SUBJECT: INDEPENDENT QUALITY REVIEW GROUP COMMENTS ON THE ABB-COMBUSTION  
ENGINEERING (ABB-CE) SYSTEM 80+ CERTIFIED DESIGN MATERIAL (CDM) AND  
ABB-CE STANDARD SAFETY ANALYSIS REPORT (CESSAR-DC)

An Independent Quality Review Group has reviewed the CDM and the CESSAR-DC, and provided their comments to the staff inspections, tests, analyses, and acceptance criteria (ITAAC) task groups. The ITAAC task groups have reviewed the comments, and those that require action by ABB-CE are contained in the enclosure.

FIGURE 2.5.1-2

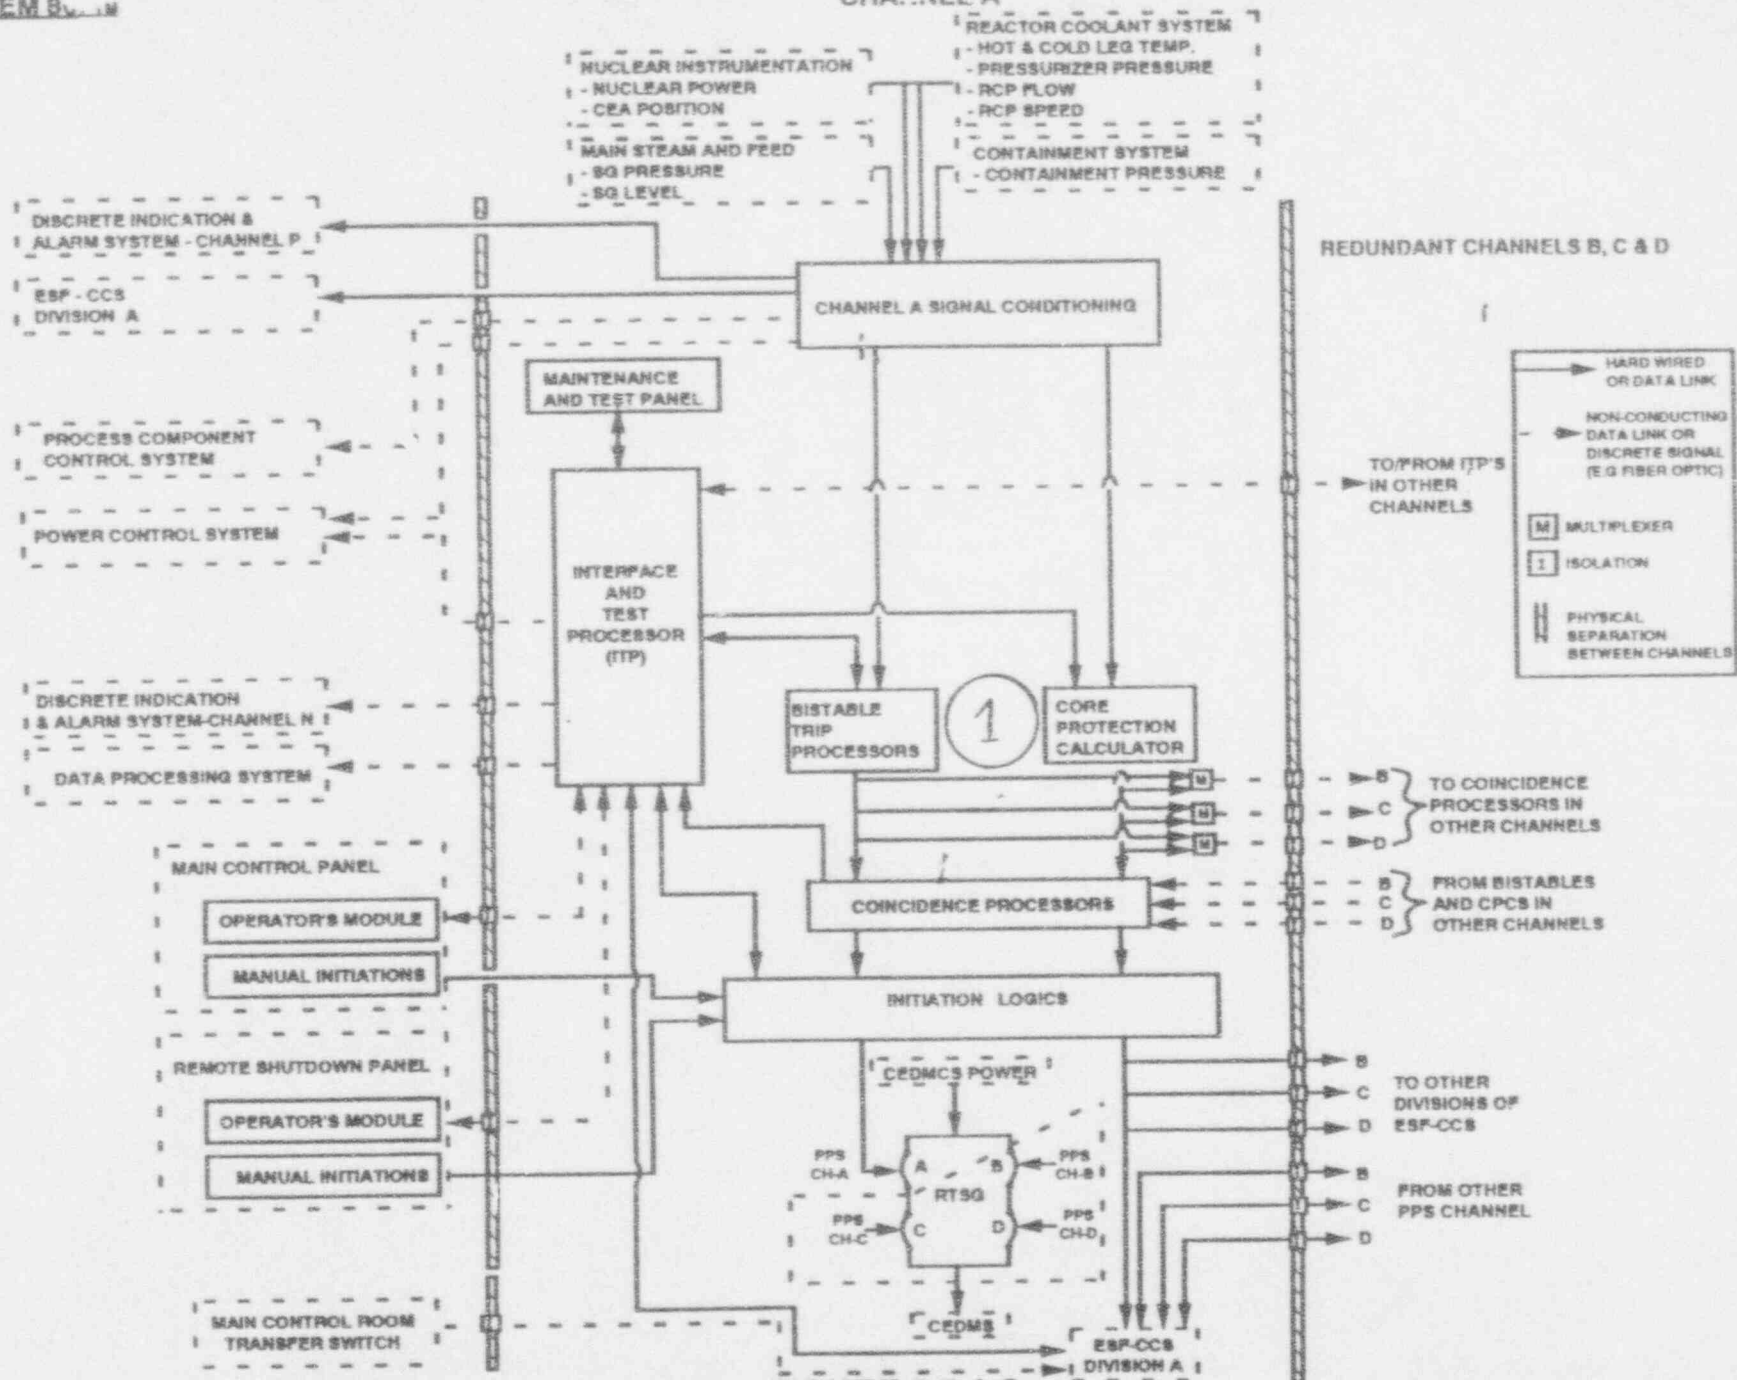
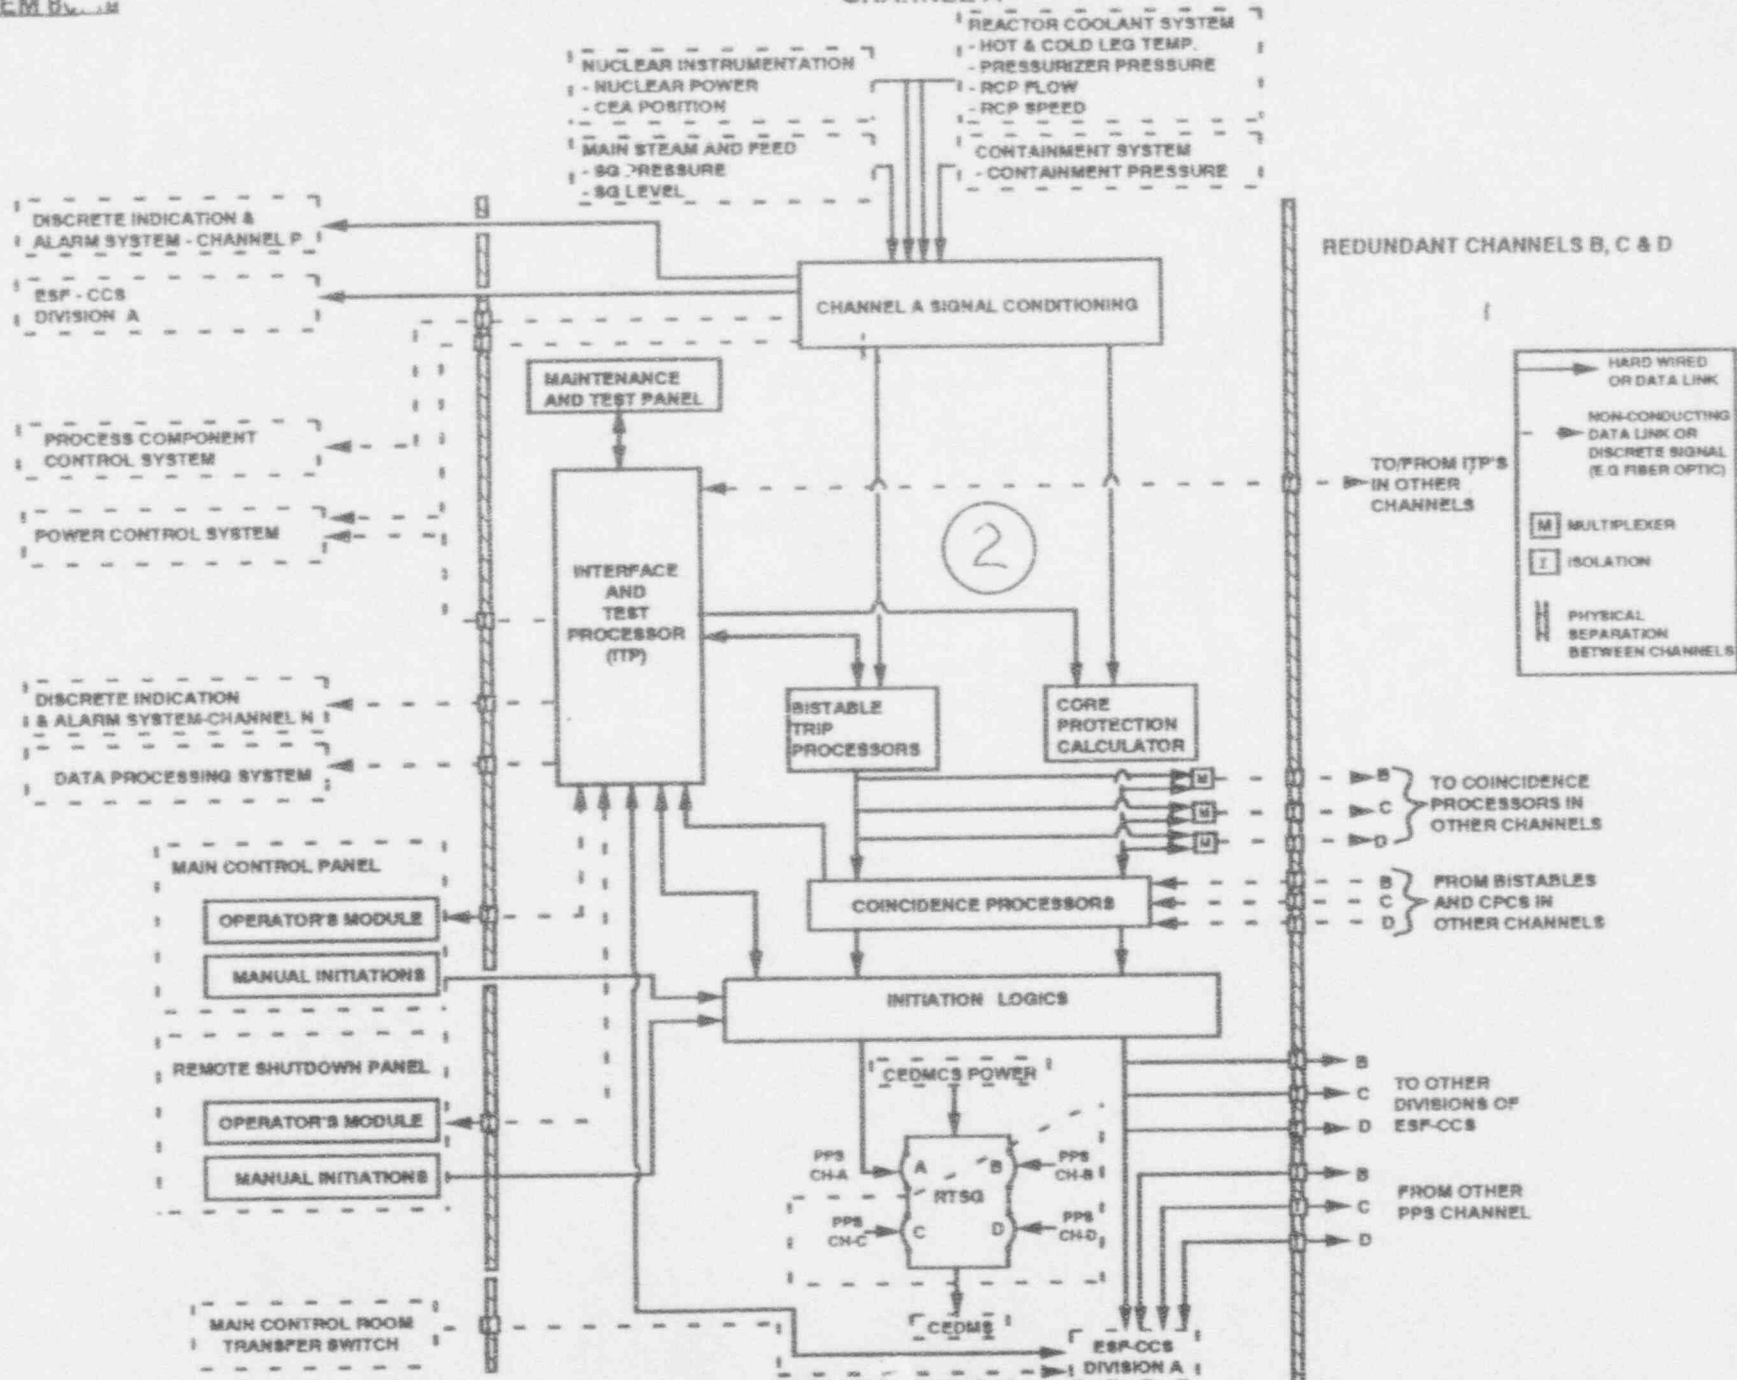
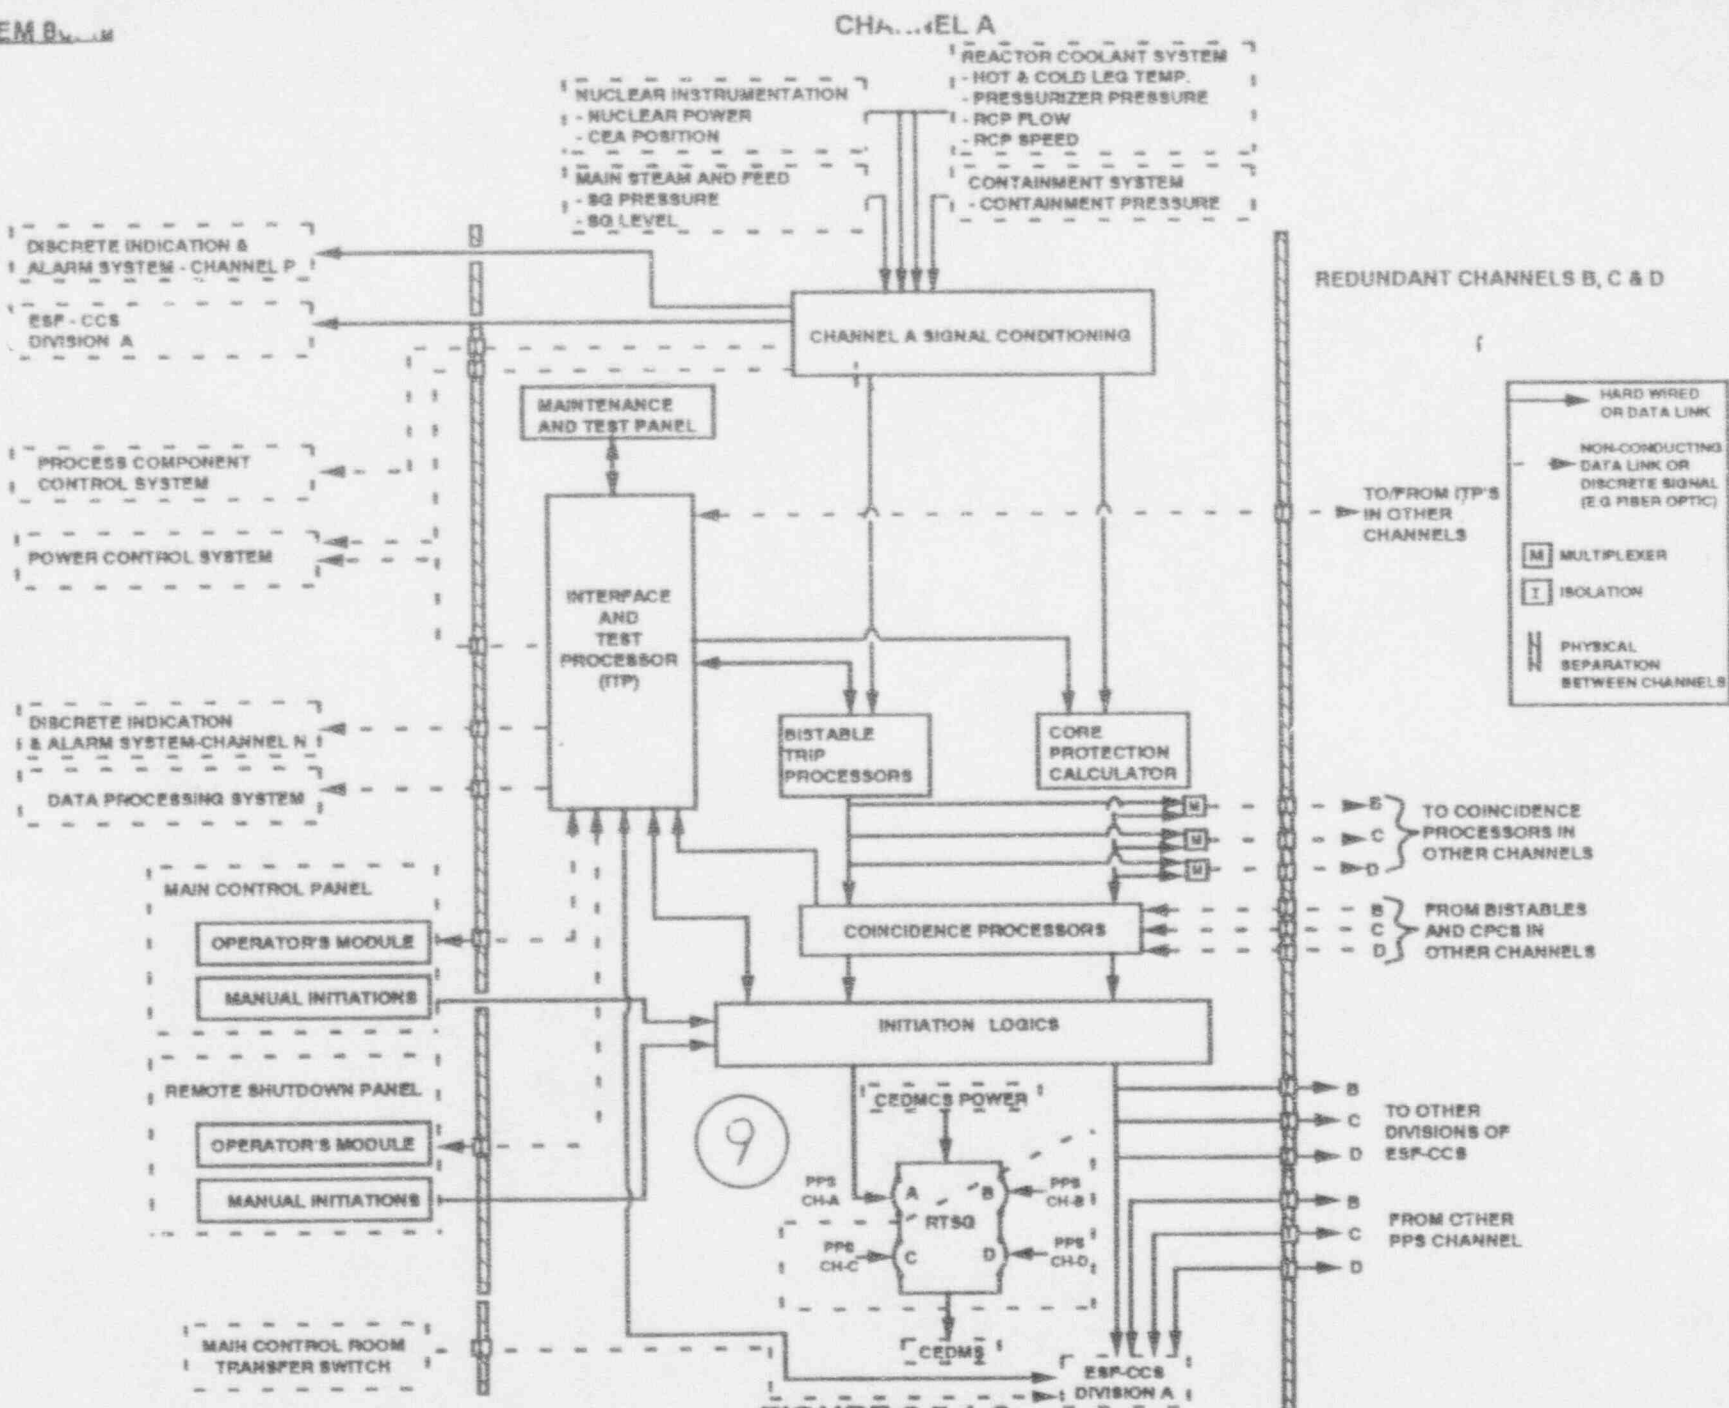
No.	Comments	Cat.	Resolution
1	Figure 2.5.1-2, "PPS Interconnection" does not clearly specify 2 coincidence/bistable processors per channel. See 2.5.1, Pg 1 (attached).	1	AGREE - PASS TO AFFILIATE
2	Page 1 of design description states that the Interface and Test processor communicates with the bistable trip processors and coincidence processors. Figure 2.5.1-2 indicates that the ITP communicates with the Core protection calculator, control room and remote shutdown panels, ESF-CS, maintenance and test panel and the initiation logics. The design description should be clarified. See Figure 2.5.1-2 (attached).	1	
3	Page 2 of CDM states that EMI qualification is applied to equipment with known EMI susceptibility based on operating environment and/or inherent design characteristics. How is "known susceptibility" to be determined? Suggest revising statement to: EMI qualification is applied for equipment based on the operating environment and/or inherent design characteristics. See also CE SSAR 7.2.1.2 Design Bases (attached).	1

10	Figure 2.5.1-2. The figure indicates that communication between the CPC and the ITP and ITP to coincidence processors is in only one direction. Is this correct? Core protection calculator output is unclear (drafting error). The coincidence processors (Figure 2.5.1-2) indicate two output paths. What is the distinction between the two? (it appears that the initiation logic block should be split to represent ESF logic in the figure and be consistent with Figure 2.5.1-3. In Figure 2.5.1.-1 the RTSG is shown feeding the CEDMCS. Figure 2.5.1-2 states CEDMS. The design description references the CEDM system (see Page 5, last paragraph)? System notations are not consistent. (see attached)	1	
11	CE SSAR 7.1.2.2. Page 7.1-2 lists Reactor Trip switchgear System (RTSS) the CDM lists Reactor Trip Switchgear (RTSG). See 2.5.1, Page 6, first paragraph. (attached-see 9 above) These should be made consistent.	1
